Appl. No. SP-4/21

SUBJECT: Major Site Plan – Preliminary & Final Approval with Variance Application No. SP-4/21
Hullfish Real Estate Company, LLC (Marmalade), Gordon Avenue
Tax Map Page 63, Block 6301, Lots 58 – 60 & 68 – 70

Re: **Hullfish Real Estate Company (Marmalade)**
Preliminary and Final Major Site Plan with Bulk Variances
Block 6301 Lots 58, 59, 60, 68, 69, & 70
16 Gordon Avenue
NC-1 (Neighborhood Center)
Application No. SP-4/21

SUBJECT: Hullfish Real Estate Company – Marmalade Restaurant Improvements
Preliminary & Final Site Plan w/Variance Application SP-4/21
Planning Board Memorandum #1
Lawrence Township Mercer County, New Jersey
Tax Map Page 63, Block: 6301, Lots: 58-60 and 68-70

FIRE TRUCK TURNING

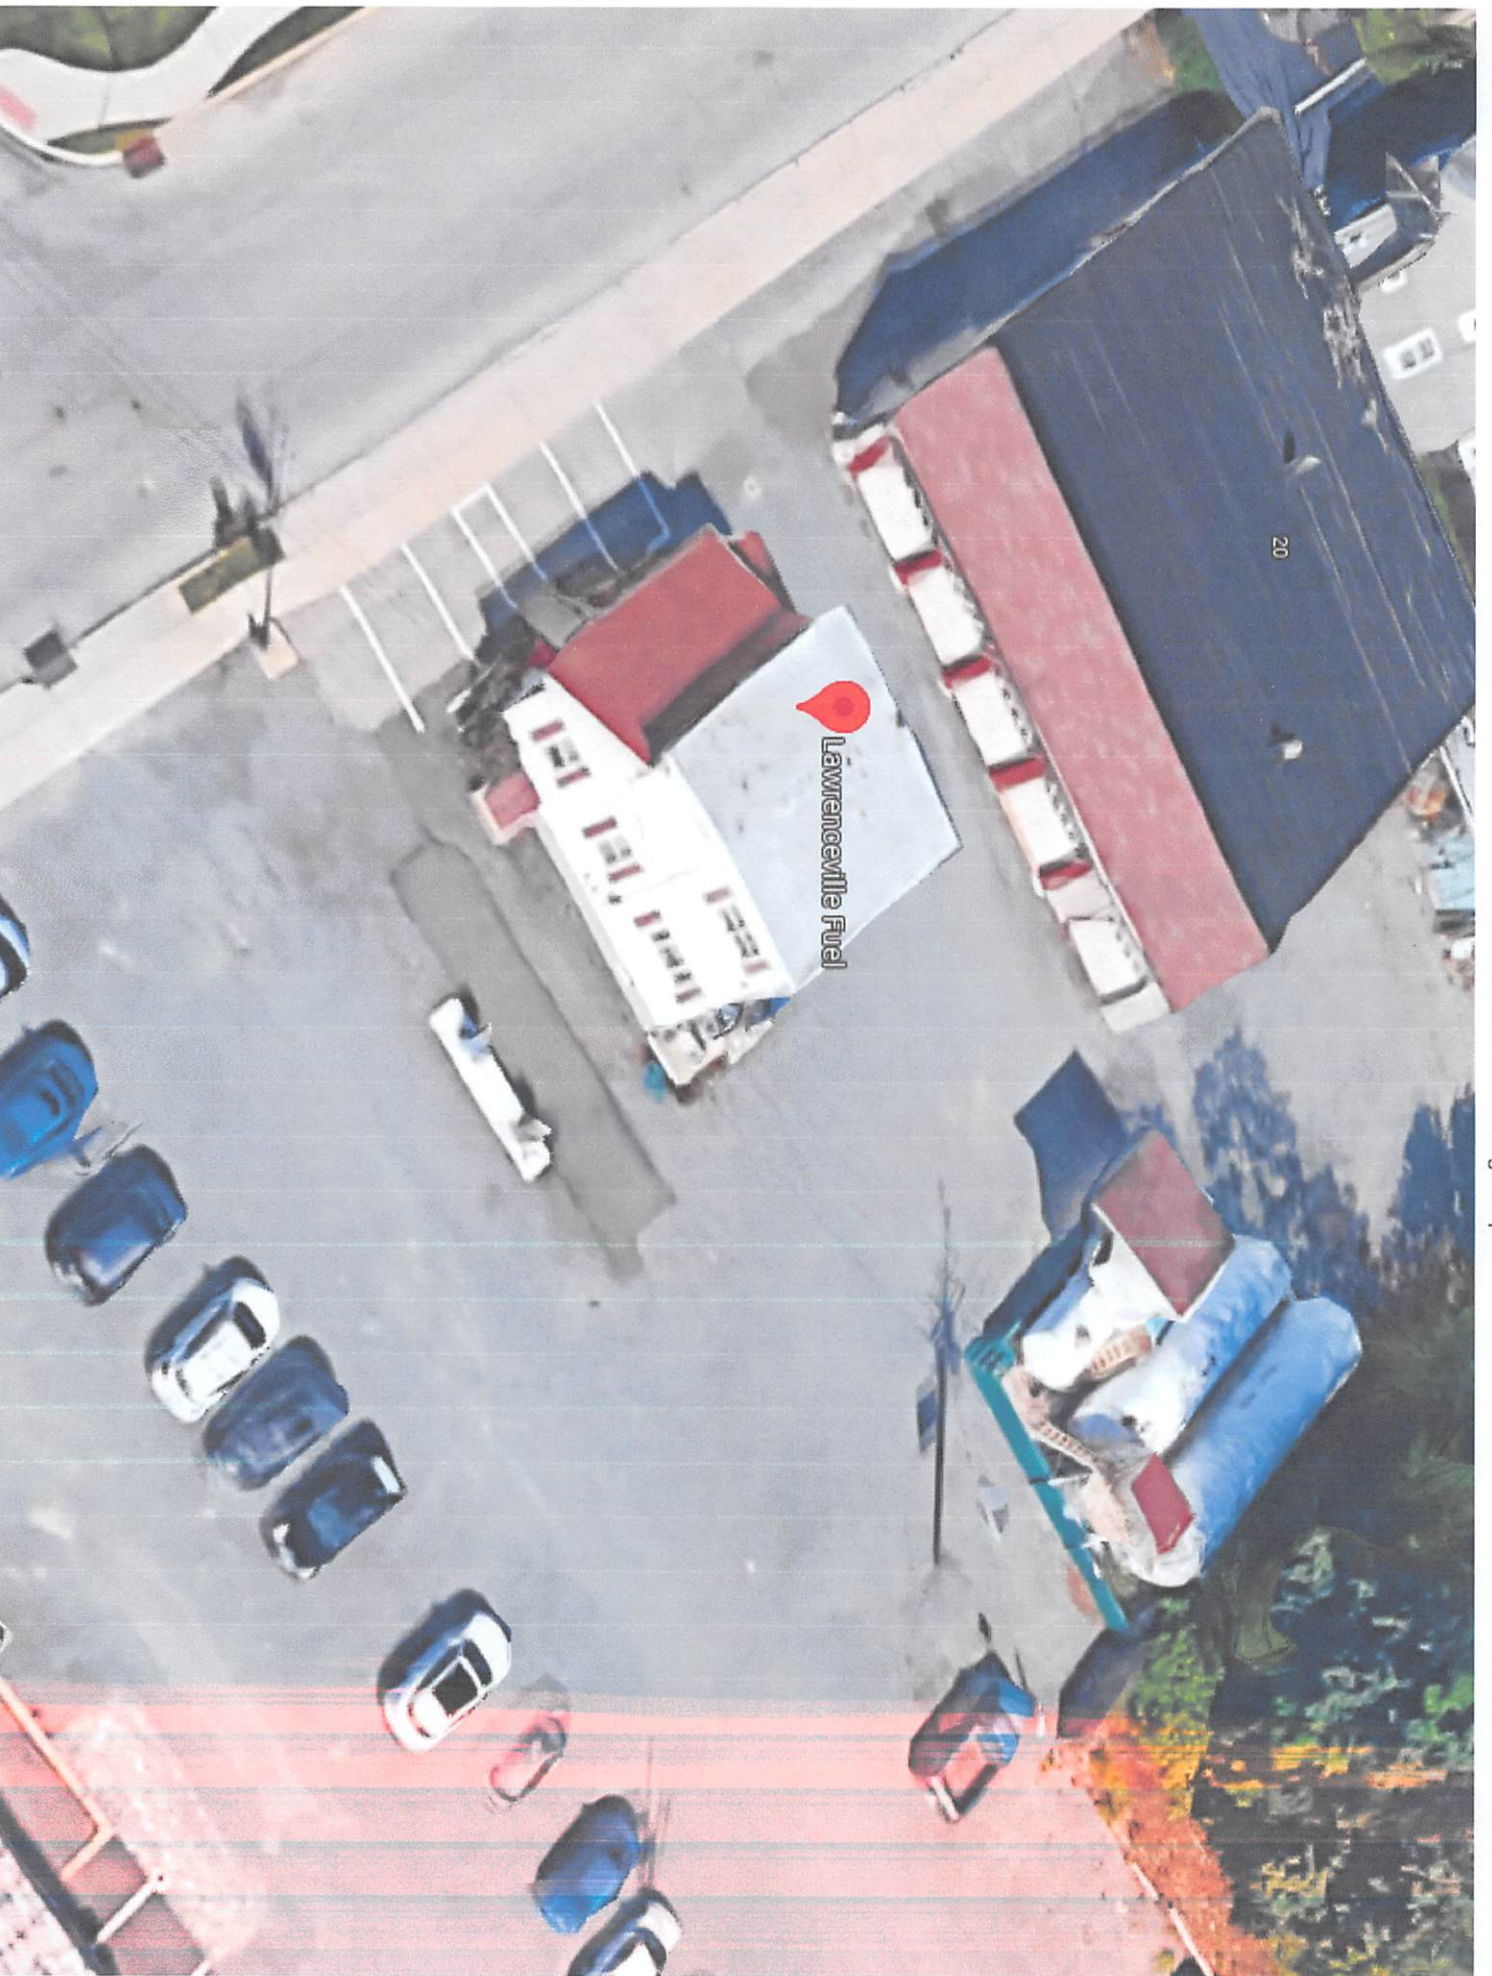
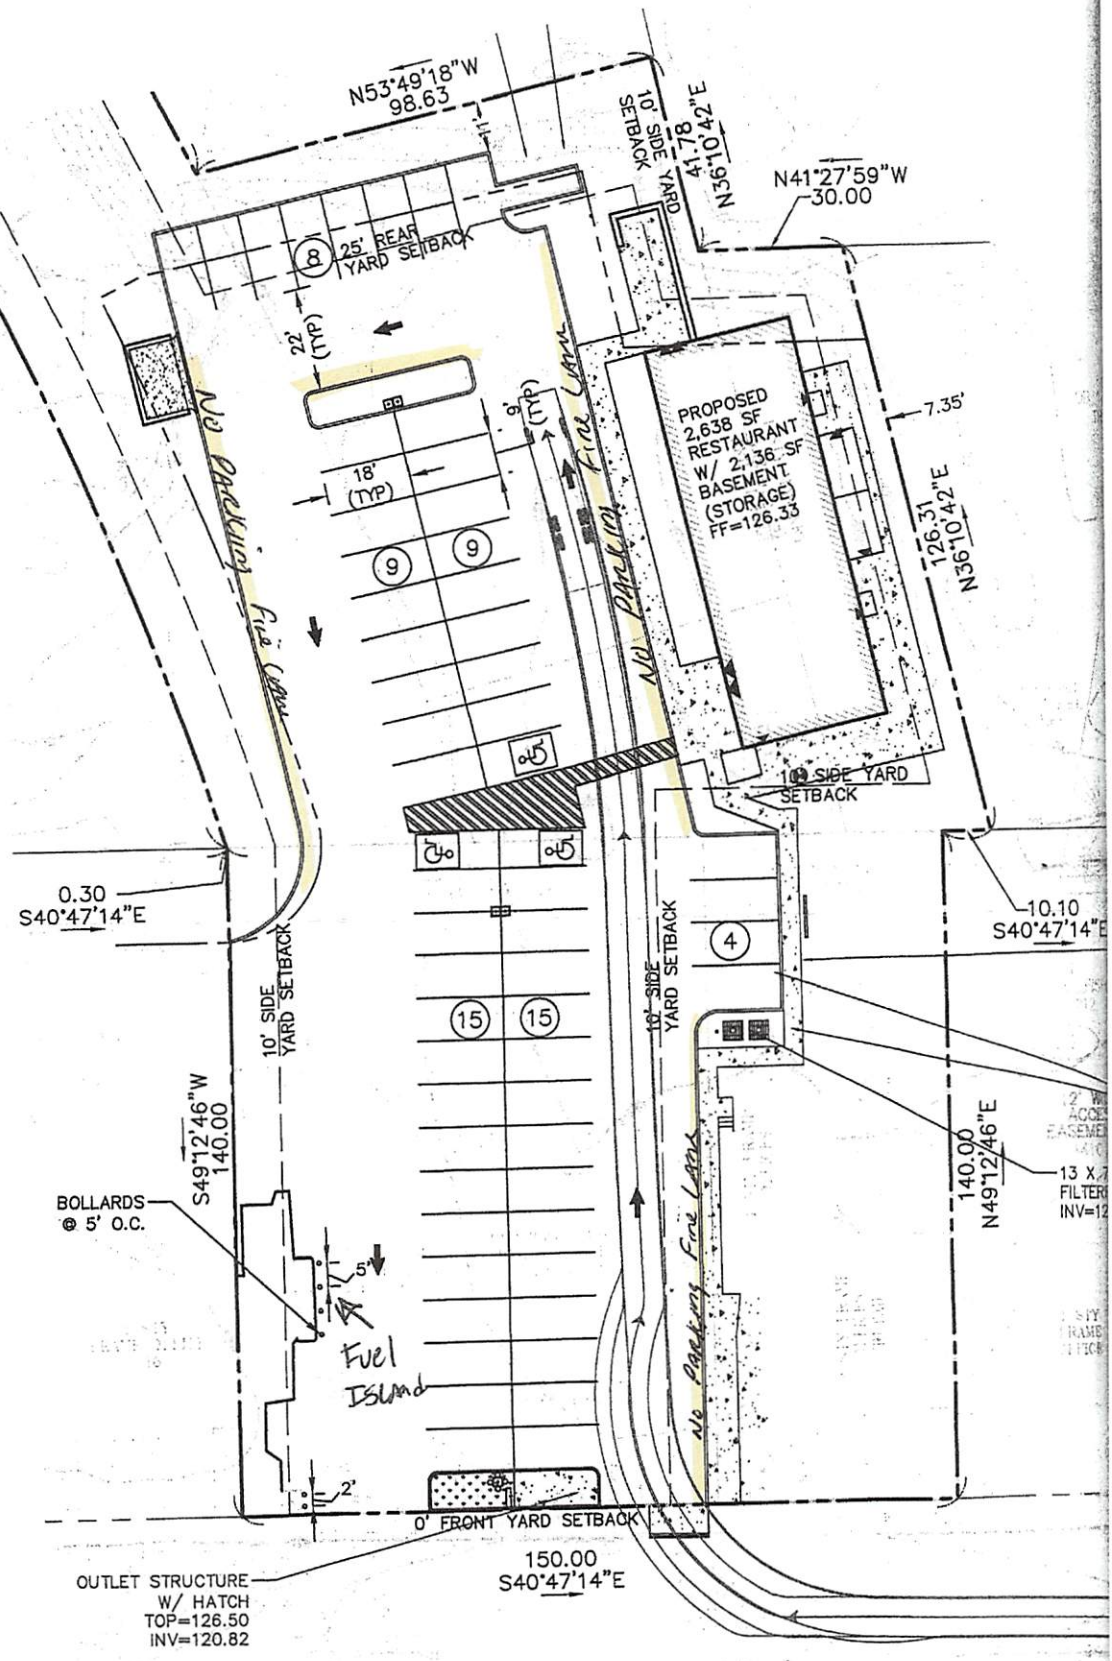
1. Fire Lane Markings and proper "NO PARKING FIRE LANE" signs to be installed in main entrance driveway, adjacent to 10 Gordon Avenue, in front of new proposed restaurant and to rear exit driveway adjacent to 16 Gordon Avenue. Allowing appropriate access for Fire Apparatus from main entrance driveway to rear of building.
2. Protection of Fueling Island from vehicular traffic and vehicles backing from parking spots is provided by four steel posts indicated on site plan. Will there be safe guards in place to prevent vehicle from mistakenly traveling between Lawrenceville Fuel Building 16 Gordon Ave and fueling island? (i.e. curbing, signage). A physical separation between parking lot and Lawrenceville Fuel Building 16 G

No PARKING
FIRE LANE
MARKINGS
1/24/2022
ET.
